UNITED STATES PATENT AND TRADEMARK OFFICE

Office Action Summary

09/681,441

FALL, PETER

FIG. 3

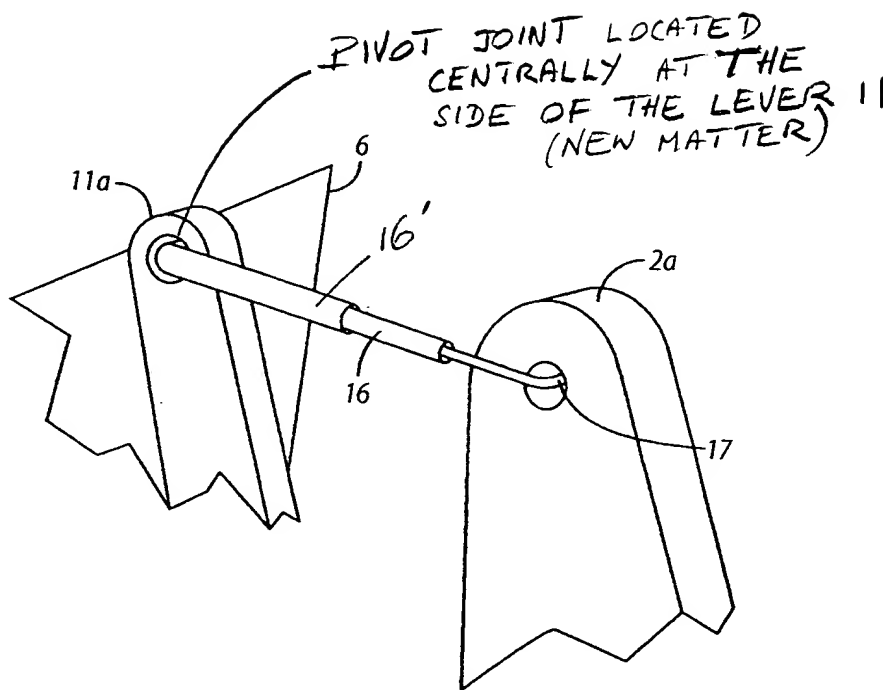
4. The amended drawings were received on December 19, 2003. These drawings are disapproved because new Fig. 3 introduces new matter, such as, (a) the number, size, shape, dimension of the telescopic elements 16 and 16 (see Exhibit I); and (b) the locations of the pivot joints as now shown in Fig. 3.

Although the original specification describes "a rigid telescoping element that is pivotally joined to the respective arms at both ends," however, the original disclosure does not describe, among other things, the following:

- (1) How many elements of which the telescoping element is comprises;
- (2) How the telescopic elements are connected to each other;

(3) The size(s), shape(s), and dimension(s) of the telescopic elements 16 and 16' relative to each other; and

(4) The specific locations of the pivot joints of the telescopic elements 16 and 16' to the pedal arm and the lever.

In other words, the original disclosure implies, e.g., that: (1) the rigid telescoping element may comprise more than two elements 16 and 16' (see Exhibit I) as now shown in new Fig. 3; (2) the shape(s) of a cross section of the telescopic elements 16 and 16' (Exh. I) may be circular, square, or rectangular, etc.; and (3) the telescopic elements 16 and 16' may be pivoted at the side of the lever 11 as now shown in new Fig. 3 or at the front surface of the lever 11 as shown in Figs. 1 and 2. The specific showing of: (a) the number, size, shape, dimension of the telescopic elements; and (b) the locations of the pivot joints within a full spectrum of possible numbers, sizes, shapes, dimensions of the telescopic elements and locations of the pivot joints is considered under the present disclosure to be new matter. *Cf., In re Smith*, 173 USPQ 679 (CCPA 1972) and *Ex parte George*, 230 USPQ 575, 578 (BPAI 1986).

Another example, the concept that the telescoping element is pivoted centrally at the side of the lever 11 as now shown in new Fig. 3 is not conveyed in the original disclosure, *i.e.*, new matter. *In re Anderson*, 176 USPQ 331 (CCPA 1973).

plainly may be illustrated in different ways. Newly submitted Figure 3 does not comport exactly with the descriptions and further does deviate from the teachings of the drawings as already submitted as evidenced by, e.g., the location of the new pivot joint of the telescoping element 16 with the lever 11. The examiner is mindful that if the best mode contemplated by the inventor at the time of filing the application is not disclosed, such defect cannot be cured by submitting an amendment seeking to put into the specification something required to be there when the application was originally filed. *In re Hay*, 189 USPQ 790 (CCPA 1976) cite in MPEP 608.01(h). The examiner respectfully disapproves new Fig. 3 and objects to the amendment to the specification for the reasons set forth in paragraphs 3 and 7 above.

7. The amendment filed December 19, 2003 is objected to under 35 U.S.C. 132 because it introduces new matter into the disclosure. 35 U.S.C. 132 states that no amendment shall introduce new matter into the disclosure of the invention. The added material which is not supported by the original disclosure is as follows: the amendment in the last paragraph of the specification. The original disclosure does not provide support, *inter alia*, for the number of telescopic elements 16 and 16' (Exh. I), size, shape, and dimension of the telescopic elements; and the specific locations of the pivot joint which is at the center of the side of the lever 11 as now shown in new Fig. 3. See explanation of the disapproval of new Fig. 3 above. Applicant is required to cancel the new matter in the reply to this Office Action.

FIG. 1

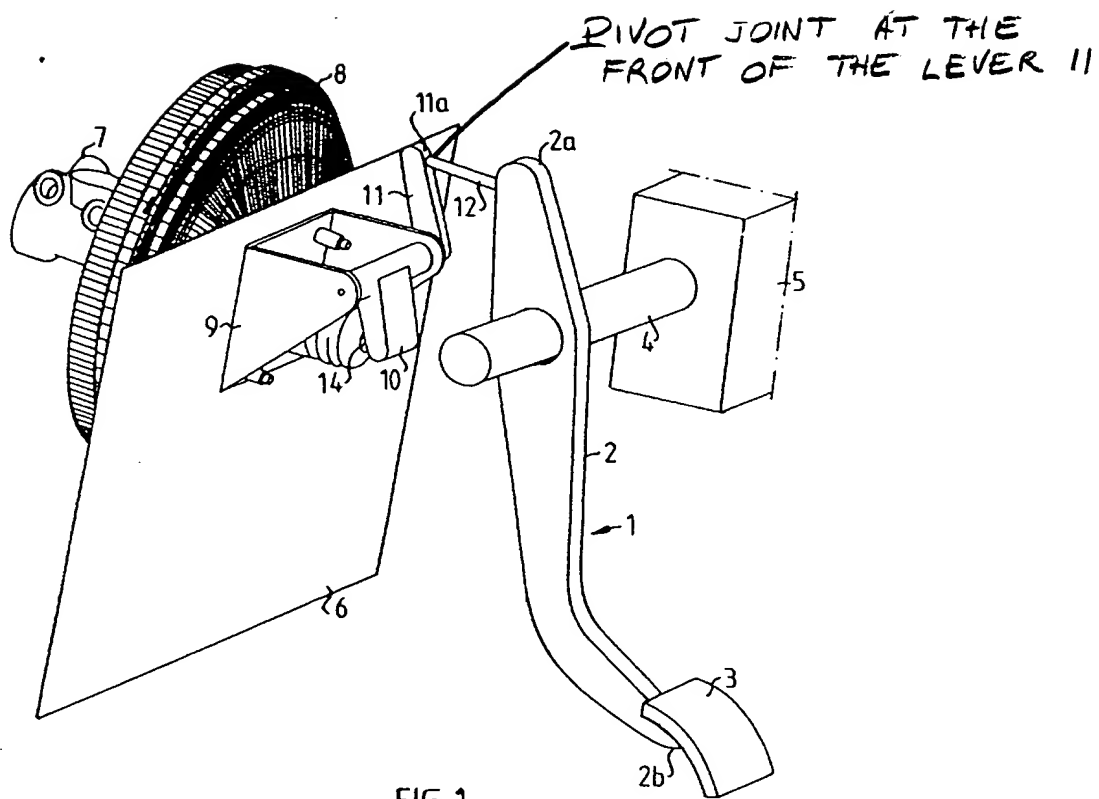
a support 26 fixed in the cab (Fig. 2);

at least one pedal arm 22 having two ends (at 18 and 22 in Fig. 1), wherein the pedal arm 22 is journaled in the support 26 for pivoting about a pivot axis 24 spaced between the two ends of the pedal arm 22;

a foot plate (unnumbered, see Exhibit II) fixed to a first portion (at 22 in Fig. 1) of the pedal arm 22 on one side of the pivot axis;

a motion-transmitting element 10 inherently disposed wholly within the cab, wherein the motion-transmitting element 10 is joined firstly to a second portion 18 of the pedal arm 22 on the other side of the pivot axis 24 from the foot plate and wherein the motion-transmitting element 10 is joined secondly to a pivotally mounted lever 4 that is configured so that pivotation thereof actuates an operating device 2; and

wherein the motion-transmitting element 10 is disposed so that the distance between the motion-transmitting element's respective attachment points (Exh. II) to the pedal arm 22 and the lever 4 is maintained at least substantially constant when there is a tensile force on the element 10 (i.e., when the foot plate is moved downwardly as shown by solid line position in Fig. 1) and is allowed to be mom-fixedly shortened when there is compressive force on the

element 10 (i.e., when the foot plate is moved upwardly as shown in dashed line position in Fig. 1); and

wherein the motion-transmitting element 10 is rigidly fixed to at least one of the pedal arm 22 and the lever 4, and is pivotally joined to the other of the pedal arm 22 and the lever 4.
